1997 - 1999: Service Bulletin: Engine Low Coolant Light Comes On (Inspect Rad. Surge Tank, Replace/Reposition)

Subject: Engine Low Coolant Light Comes On At Start-Up (Inspect for 2nd Design Radiator Surge Tank and Replace/Reposition)

Number: 99-06-02-016

Models: 1997-1999 Chevrolet Corvette (1997 Models Built Prior to VIN Breakpoint V5104277)

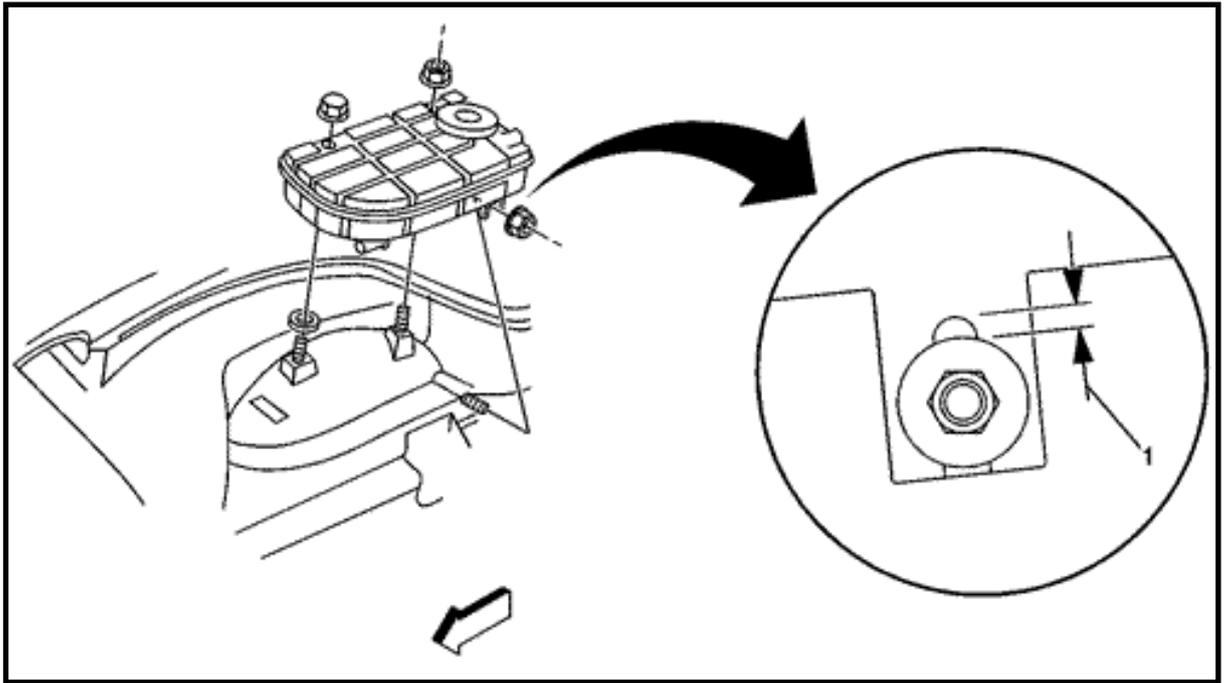
Cause: This condition may be caused due to the low coolant sensor being mounted in the rear of the radiator surge tank. When the vehicle is parked with the front lower than the rear, the coolant settles in the front half of the surge tank and with the switch in the rear of the tank, the switch float may be low enough to trigger the light. The "low coolant" light may come on if:

1. For 1997 vehicles built prior to VIN breakpoint V5104277, replace the radiator surge tank and inspect for an out of position wiring harness under the tank. To repair the harness, position the harness downward and secure with a tie strap. To determine if the surge tank is of the first or second design, inspect the low coolant switch cavity in the surge tank. If the surge tank cavity extends 16 mm (5/8 in) below the bottom of the surge tank, the tank is of a second design tank. If the cavity is less than 15 mm (19/32 in) replace the tank with P/N 10405218.

2. For all vehicles, check the level of the tank by viewing the lower mount on the tank. Less than 2 mm (.08 in) (#1) of the mounting slot should be visible above the attaching nut. If the gap is greater than 2 mm (0.08 in), loosen the surge tank and hold in a downward position to achieve less than a 2 mm (0.08 in) gap above the attaching nut. Tighten the bottom nut first, then both top nuts. **Tighten**

Tighten the nuts to 10N·m (89 lb in).

3. Verify coolant level in surge tank:
 - If engine coolant is hot, above 83° C (180° F), fill the coolant surge tank 12 mm (1/2 in) above the cold indicator mark.
 - If the engine coolant is at ambient room temperature, fill to the top of the cold indicator mark.
